# 42nd Avenue - Proposed New Residential Construction Project (SDCI #3019962)

SEATTLE DESIGN REVIEW

July 16, 2015 | Early Design Guidance Meeting 1  
November 5, 2015 | Early Design Guidance Meeting 2  
April 21, 2016 | Early Design Guidance Meeting 3

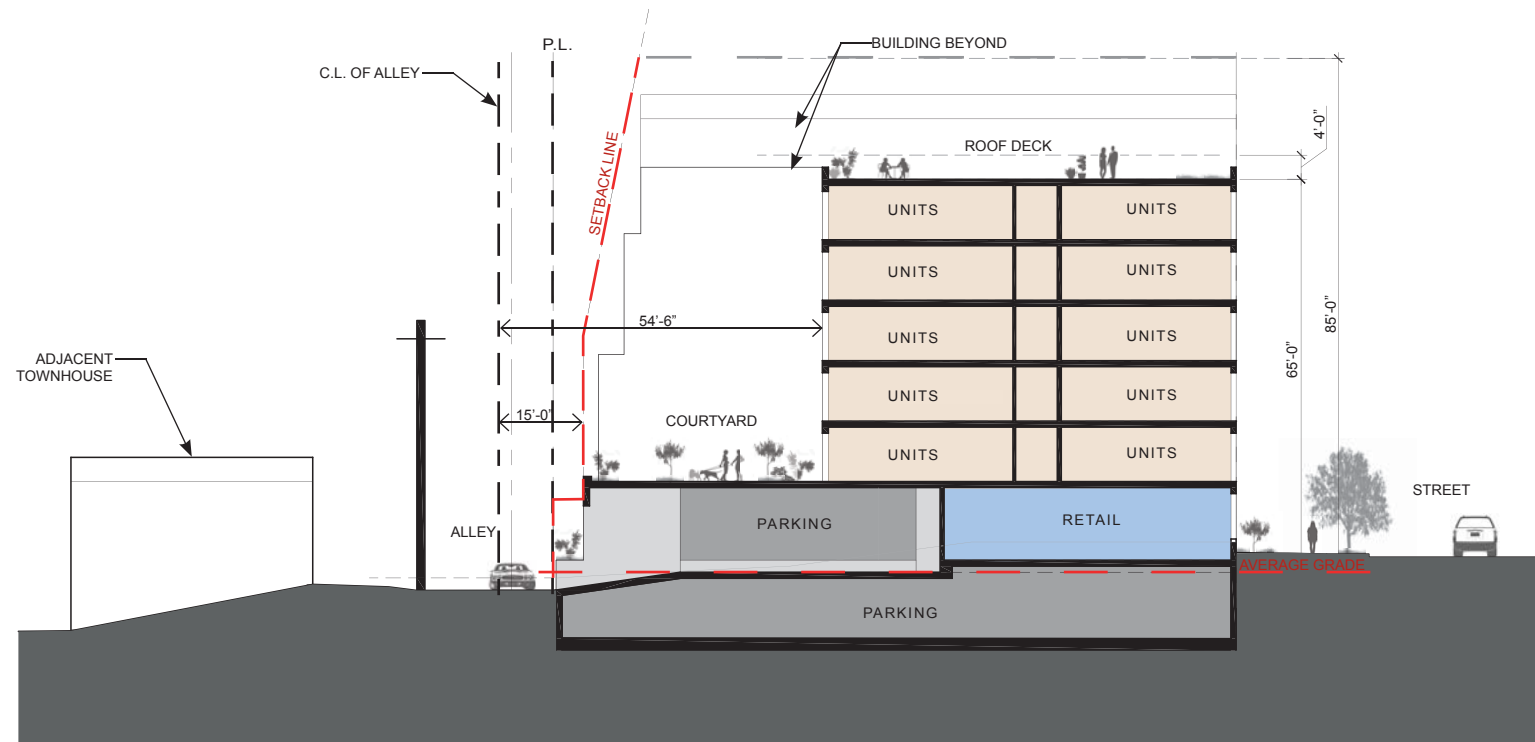
**The Board noted that a generous north setback is crucial for providing adequate access to light and air for the north-facing units and the adjacent site. The Board felt that the proposed 2'-0" setback and the 6'-6" modulated recesses were minimal, and suggested providing alternatives that explore a thoughtful massing response. (CS2-B, CS2-D, CS3-A, PL1-A, DC2-A, DC2-B, DC3-B)**

**The Board agreed that the proposed modulation is not essential to reducing the perceived height, bulk and scale of the north facade. This facade could be simple yet well-composed, and should incorporate a larger setback. (CS2-B, CS2-D, CS3-A, PL1-A, DC2-A, DC2-B, DC3-B)** As the northern facade has been significantly reduced in area, we are maintaining the 2'-0" setback from the northern property line and are incorporating some modulation to provide additional visual interest. The new location for the courtyard also provides a more respectful transition between the northern property and the proposed building, while accommodating needs for privacy and open space for everyone.

The north facade area has been reduced to nearly half the depth of the site out of sensitivity to the property to the north. The large courtyard has been relocated to the northeastern corner of the site to allow this property greater access to light and air.

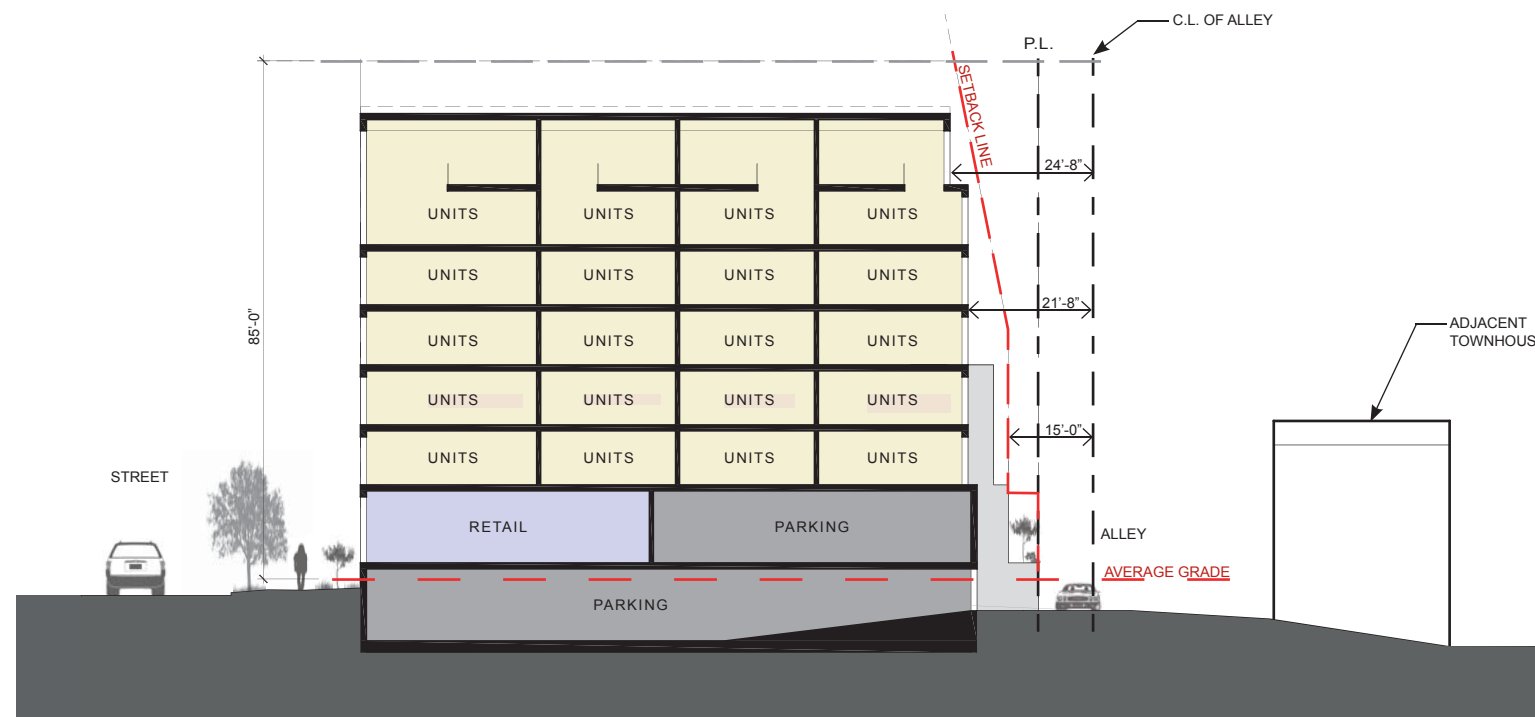
**The Board agreed that the proposed massing at the alley respects the sensitive transition to the LR3 zone by providing adequate access to light and air and reducing the perceived height, bulk and scale of the east facade. (CS2-D, CS2-III)**

**The Board supported the central courtyard as it provides a break in the massing, further reducing the perceived bulk and scale of the east facade. (CS1-D)**

**The Board felt that the north facade should demonstrate greater sensitivity to existing context and potential development by providing adequate access to light and air and relief in massing. (DC2-B)**

**The Board supported stepping back the massing at the upper levels at the east facade, as it increases access to light and air for the LR3 zone and helps to reduce the perceived height and bulk of the structure. (CS2-D, CS2-III)**

The courtyard is maintained, but moved to the northeast corner. All setbacks between zones and adjacent properties have either been met or surpassed.

An open courtyard space was created at the northeast corner of the site providing a break in the massing and allowing adjacent LR zones greater access to light and air and creating a transition from the commercial zoning to the residential zoning. The open courtyard space was created by stepping the eastern facade of the building back from the center of the rear alley by 55', reducing the impact of the building massing and allowing more sunlight access for the property to the north.

In order to allow the property to the north to have more access to light and air, the courtyard was located at the north eastern corner of the site and the east facade is held back nearly 55' from the centerline of the alley. The north facade is held back 2'-0" minimum from the northern property line and units have been oriented to minimize openings along the north facade.

The building massing complies with all required setbacks between commercial zones and residential zones and provides landscaping and a courtyard space along the eastern property line to minimize the impact of the massing on the residents of the LR3 zone.

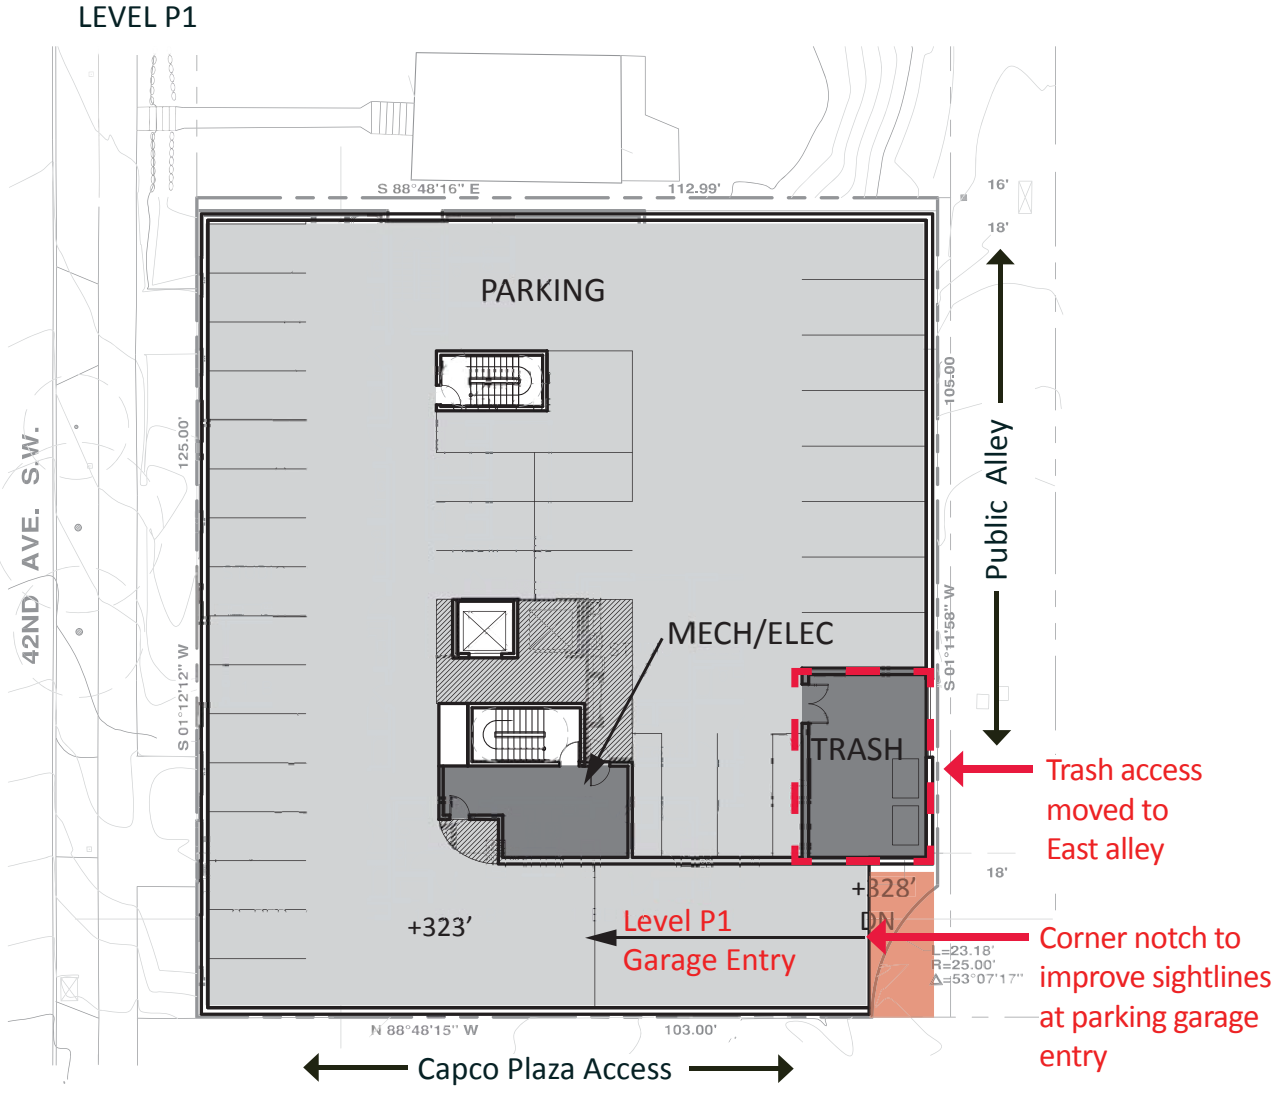
The Board noted that the alley is heavily used by pedestrians and cars, and was concerned about the proposed locations for parking access and service uses in regards to safety and visual impacts. (DC1-B, DC1-C, DC1-I)

The Board supported the notch at the SE corner to improve sightlines for vehicles maneuvering the corner. (DC1-B)

Parking access has been revised so there are two entrances off the east alley creating separation between the public alley and Capco Plaza Alley.

Notch has been maintained to improve vehicle safety at the SE corner.

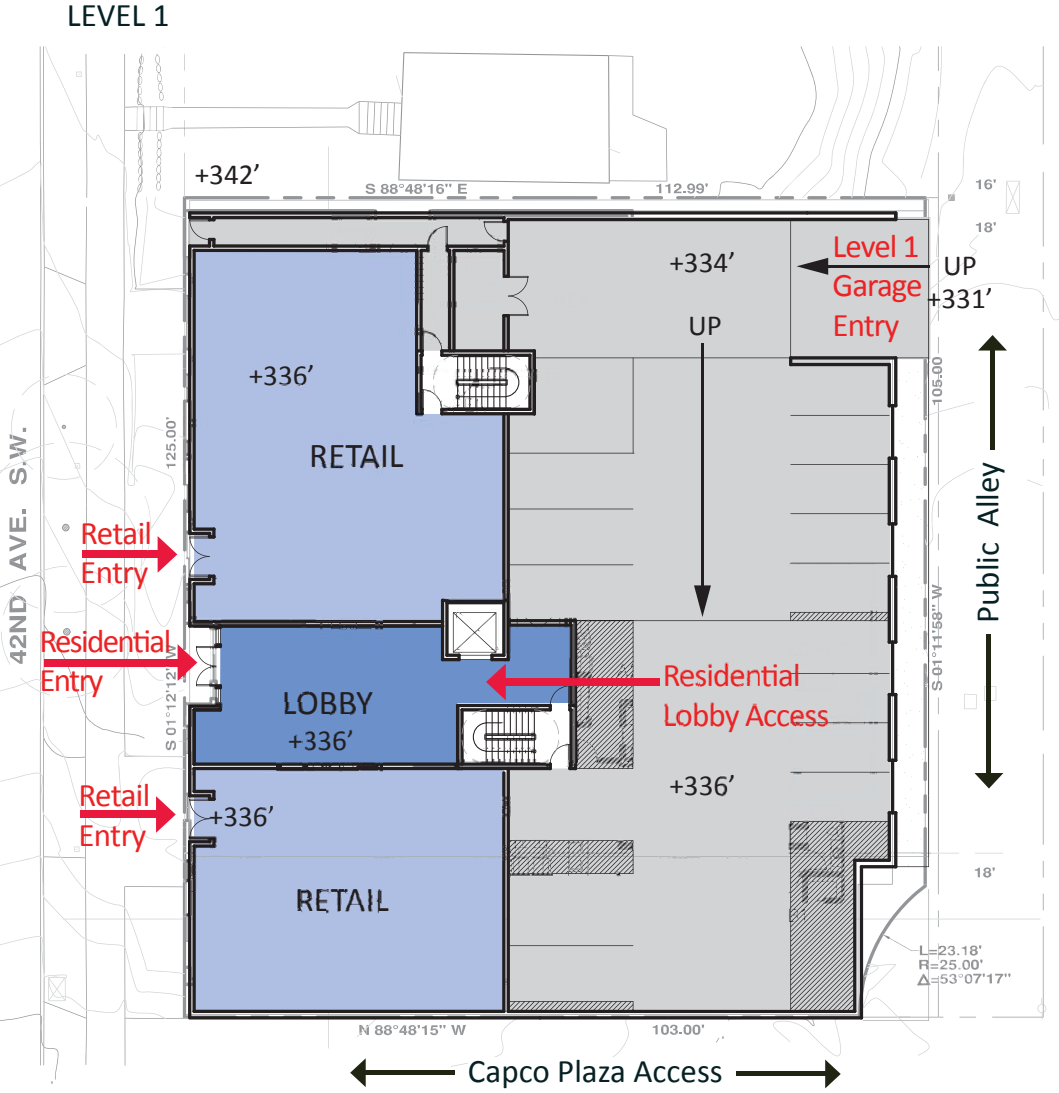
The Board requested the location of trash pickup be moved to east side of garage. (DC1-C)

Trash pickup has been moved to east side of garage and has a roll-up door on alley.

WEST ELEVATION

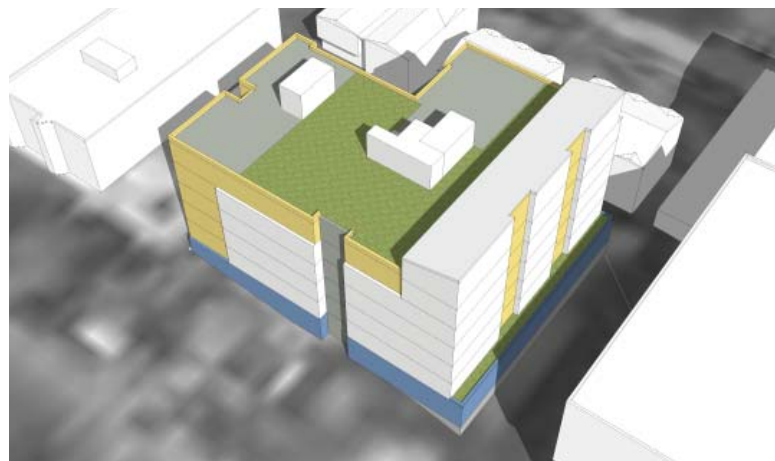
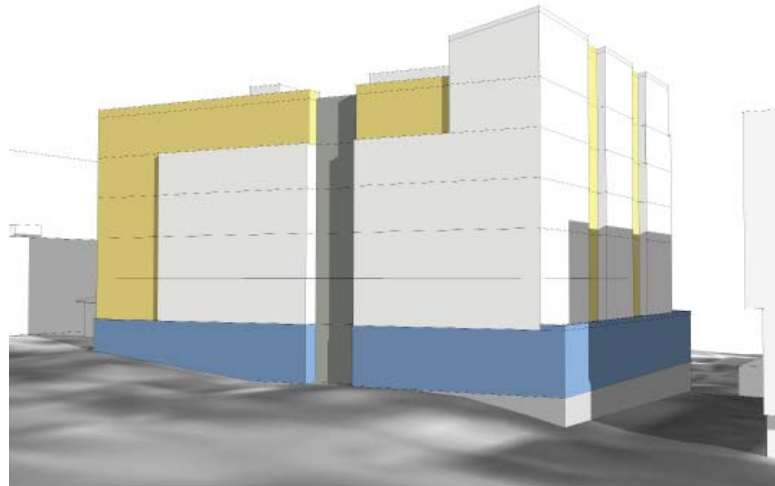
**The Board supported massing pulled up to the property line along 42nd, indicating that the strong urban edge with no upper setbacks fits the context and responds to the evolving street wall. (CS2-A, CS2-C, CS2-I, CS2-D, DC2-I, DC4-D)**

**The Board supported activating the street with continuous retail uses**

**The Board was concerned with the proposed 10' recess at the residential lobby**

Massing has been pulled to the property line along 42nd. The only setback occurs as a 4'-0" setback above the entry. Balconies within the setback reinforce the urban edge and put eyes on the street.

With the exception of the residential entry, the entire street-facing facade will be commercial use.

The recess has been reduced to 4'-0" at the residential lobby.

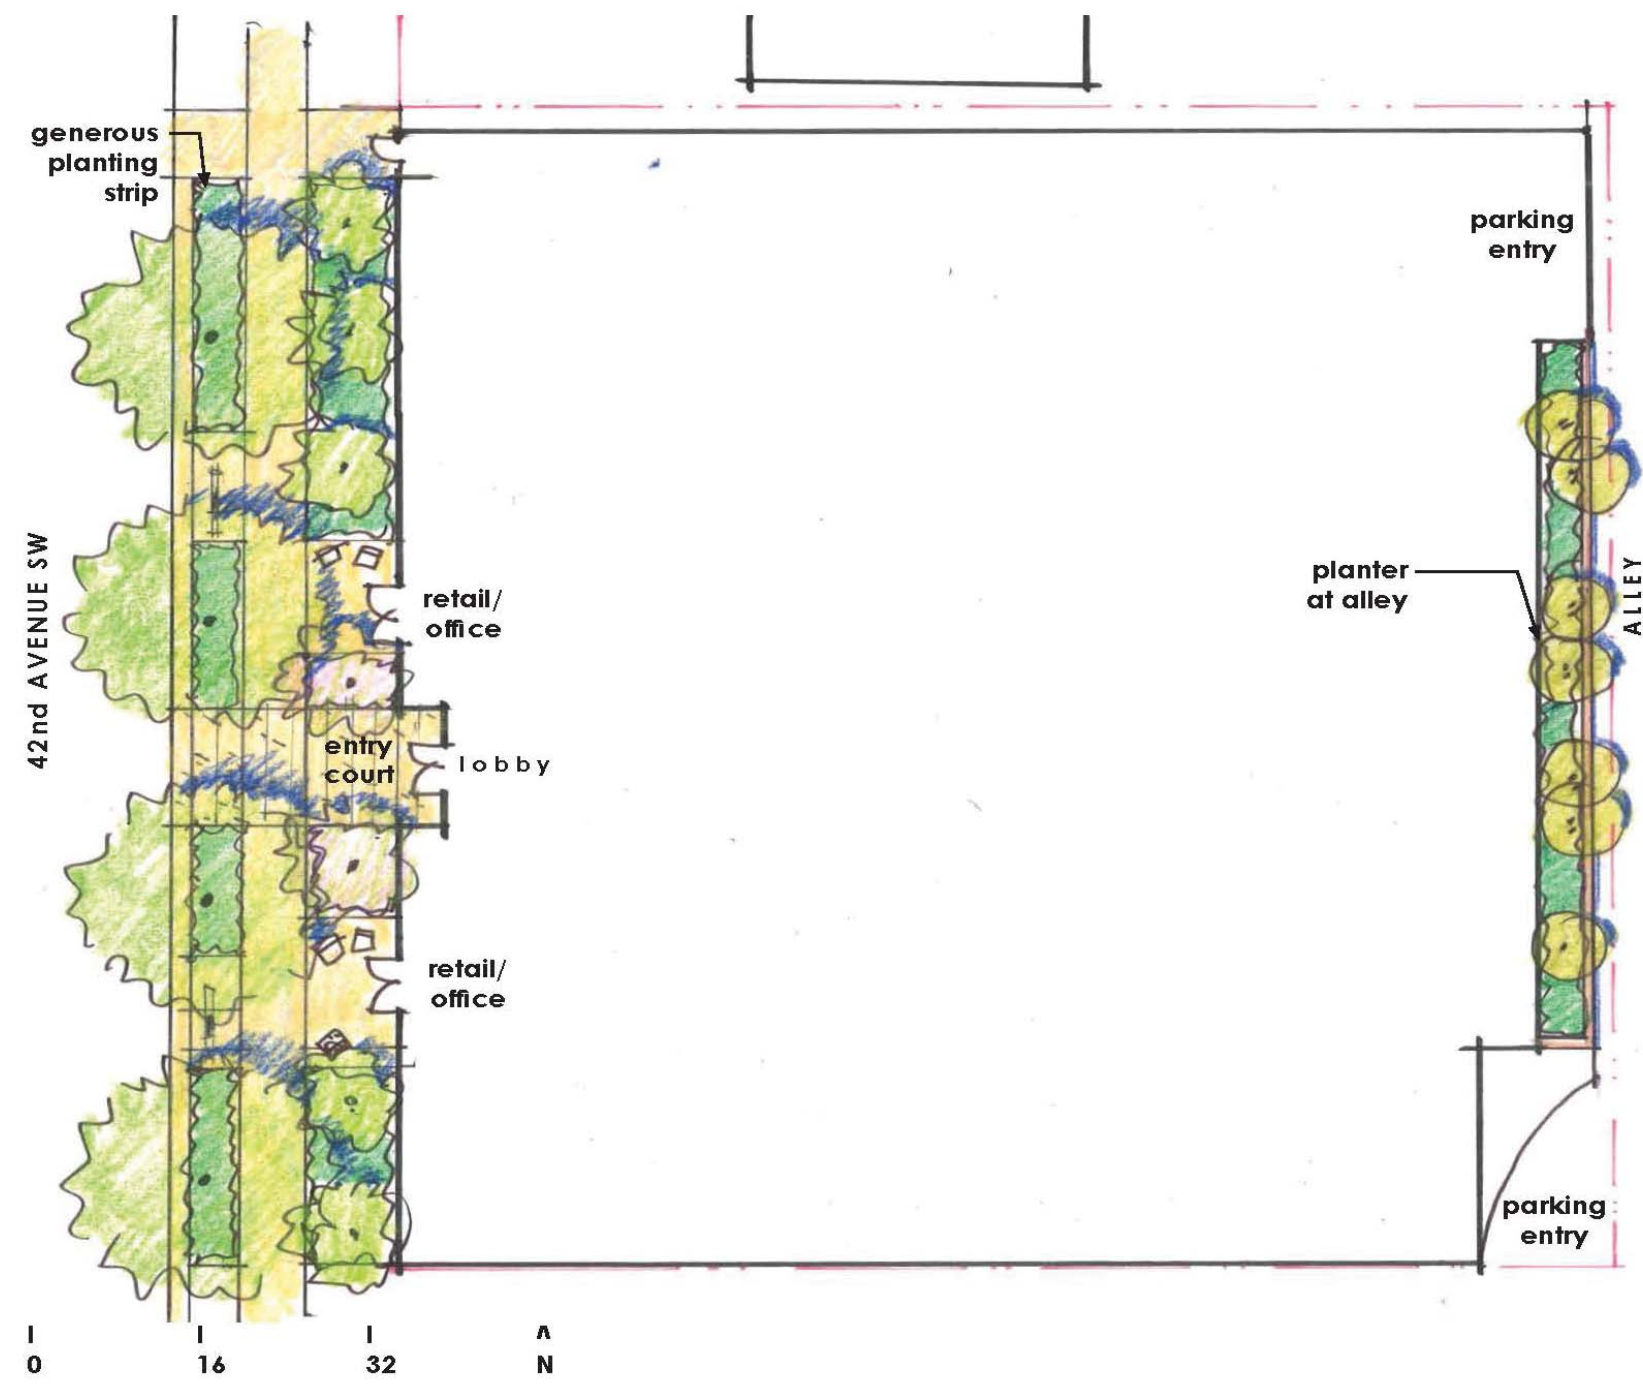
**The board indicated that site planning and massing should result in an urban form that establishes a sense of place and provides open space connectivity (CS1-D, CS2-D, CS2-III)**

**The board discussed locating on-site open space in a manner that more directly interacts with the streetscape and enhances the pedestrian experience at the sidewalk. (CS2-A, CS2-B, CS3-A, CS3-B, PL1-A, DC2-B)**

**The board felt that shifting the open space to the NE corner would help reduce bulk & scale. (CS3-B, DC2-A, DC3-A, DC3-B, DC3-C)**

Typical of most mid-block developments and mixed use buildings, a strong retail frontage on the ground floor is emphasized through extensive glazing and rhythmic bays typical of other storefronts in the Junction. The southwest corner of the building is emphasized by the taller volumes allowed in the NC3-85 zone on the southern portion of the site which assists in anchoring the building on the site. The lobby entry is recessed allowing for improved pedestrian circulation and provides a transition between the busy sidewalk and building interior as one enters. In order to provide areas for fostering community and a sense of home within the building, two extensive outdoor spaces are provided for building residents and guests: a roof deck and an outdoor courtyard space.

In order to maintain a strong street retail frontage, the building is held at the property line. However, the wide green strip in front of the building will be planted similar to other rhythmic planting areas in the area. The lobby entry for the building is recessed in order to provide more space for circulation in and out of the building, as well as provide a physical delineation of the entry. Both of these moves are consistent with other developments along 42nd and elsewhere in the Junction.

Moving the courtyard space to the NE corner of the building not only helped reduce the bulk and scale and impact of those on the surrounding LR zones, but it also allowed for an opportunity to provide building residents and guests with an additional shared outdoor space and light and air access to neighboring properties.
